PROPOSED REVISED TECHNICAL SPECIFICATION PAGES

TURKEY POINT UNITS 3 AND 4  
Docket Nos. 50-250 and 50-251

Marked-up Technical Specification Pages

FIGURE 6.2-1  
OFF-SITE ORGANIZATION FOR FACILITY  
MANAGEMENT AND TECHNICAL SUPPORT

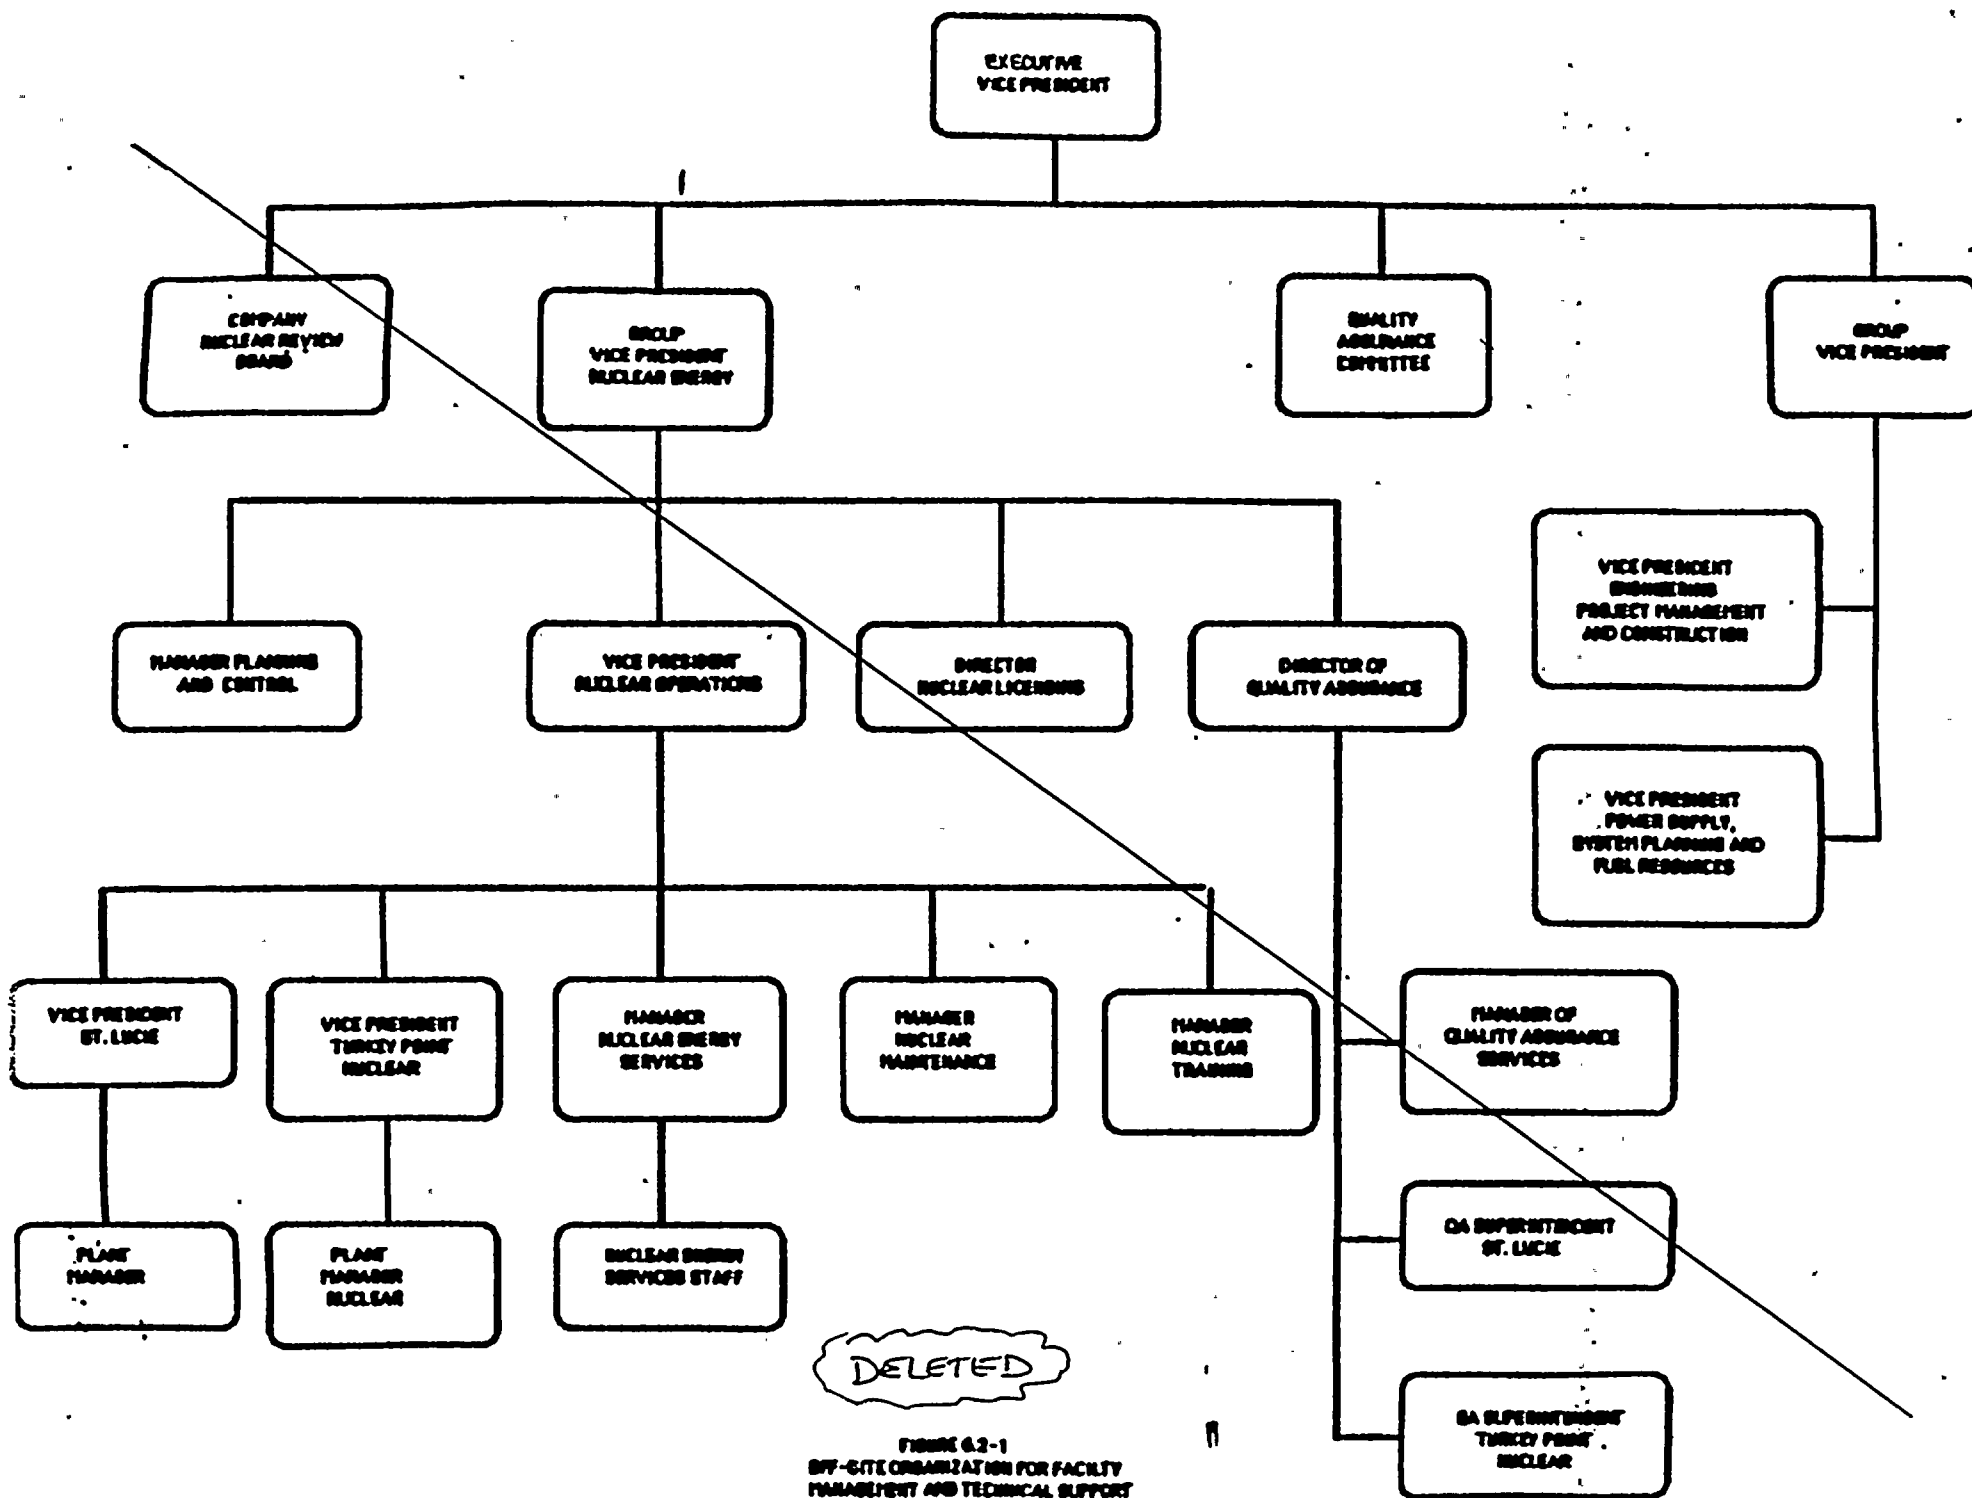
3.2-3	K (z) vs Core Height
3.2-3a	Deleted
3.2-4	Maximum Allowable Local KW/FT
4.12-1	Sampling Locations
5.1-1	FPL Turkey Point Site Area Map
6.2-1	<del>Offsite Organization for Facility Management and Technical Support</del> DELETED

~~The offsite organization for facility management and technical support shall be shown on Figure 6.2-1.~~

6.2.1 ~~OFFSITE~~ ONSITE AND OFFSITE ORGANIZATION.

Insert for Technical Specification 6.2.1, "Onsite and Offsite Organization", page 6-1

An onsite and an offsite organization shall be established for <sup>Facility</sup> operation and corporate management. The onsite and offsite organization shall include the positions for activities affecting the safety of the nuclear power plant.

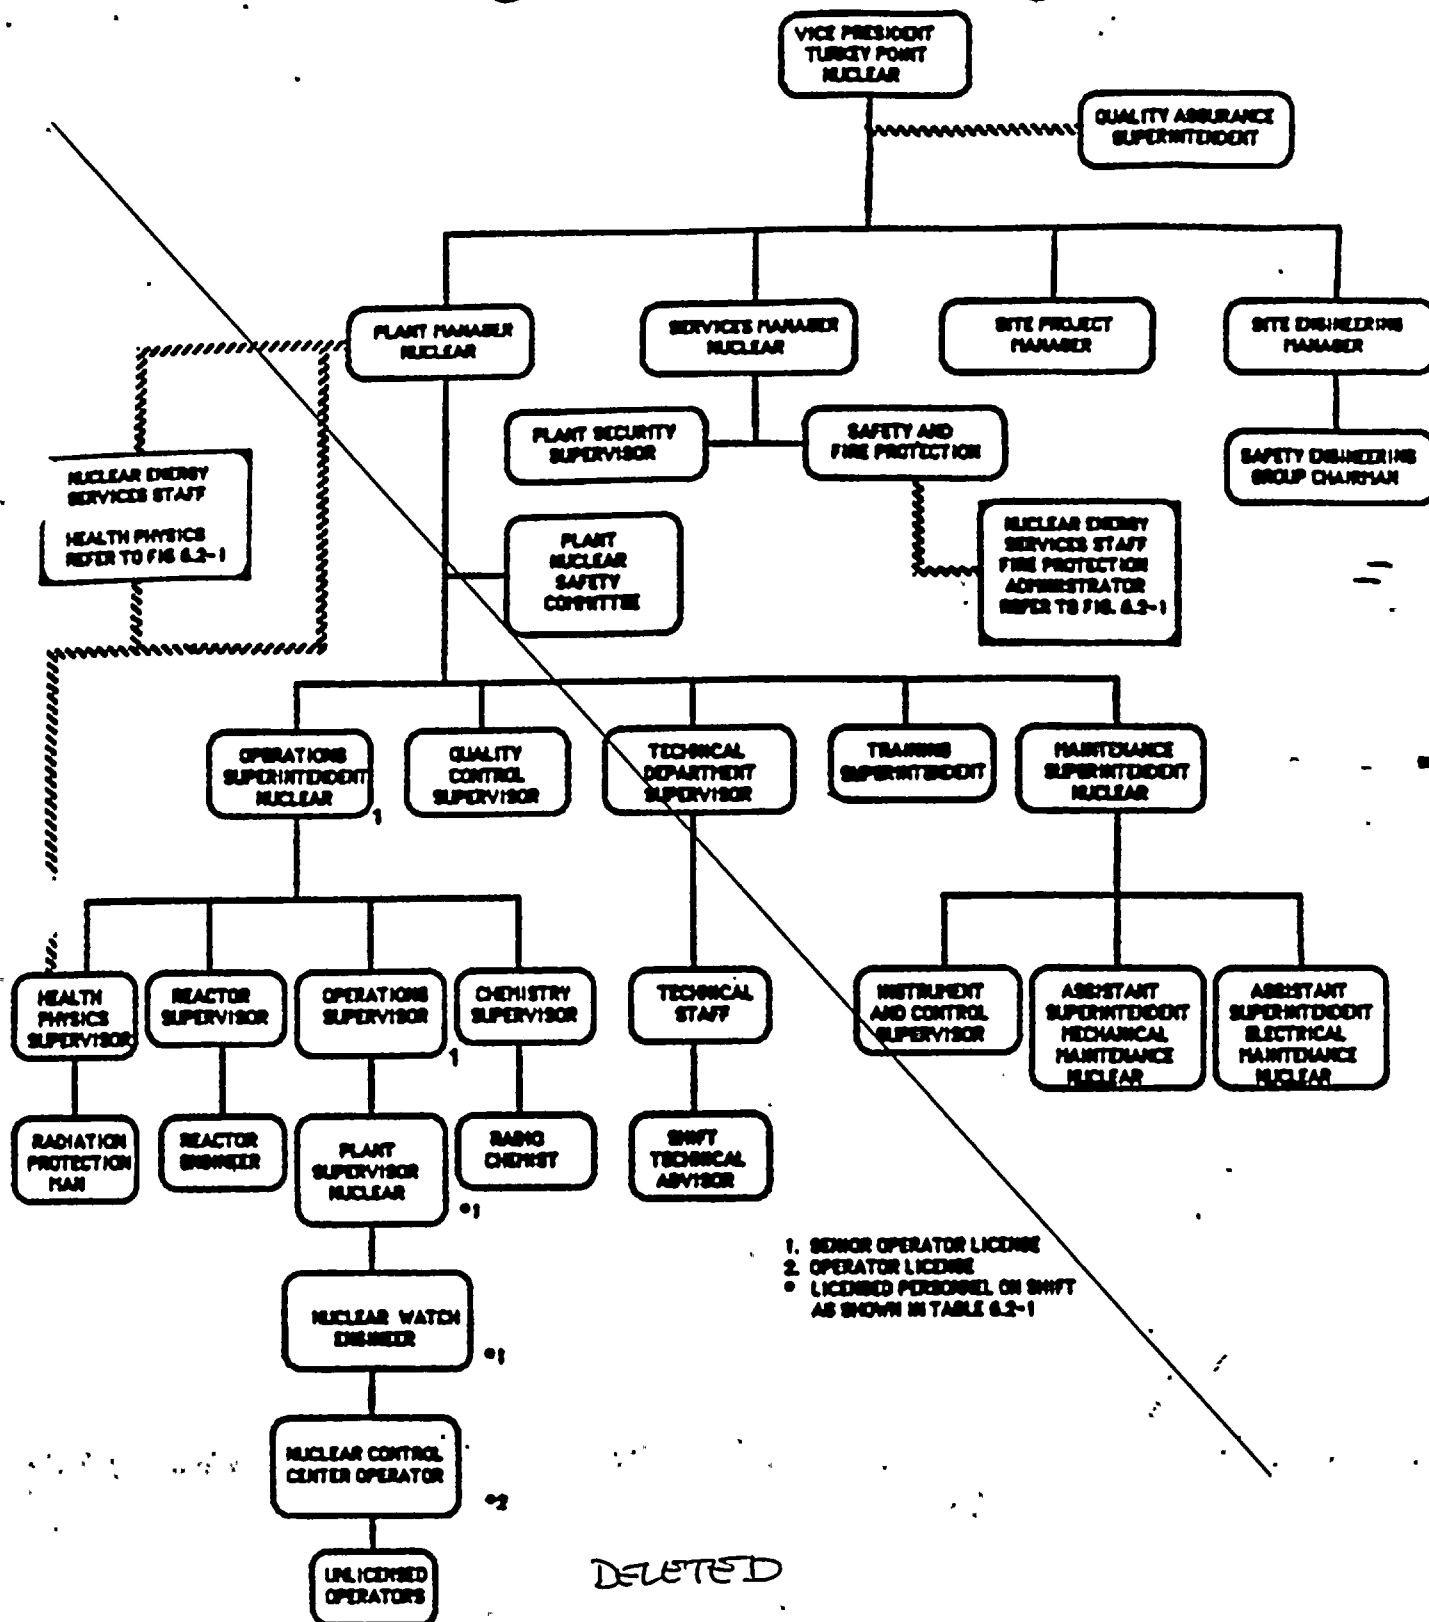
The Facility organization shall be ~~as shown on Figure 6.2-2~~ and:

subject to the following
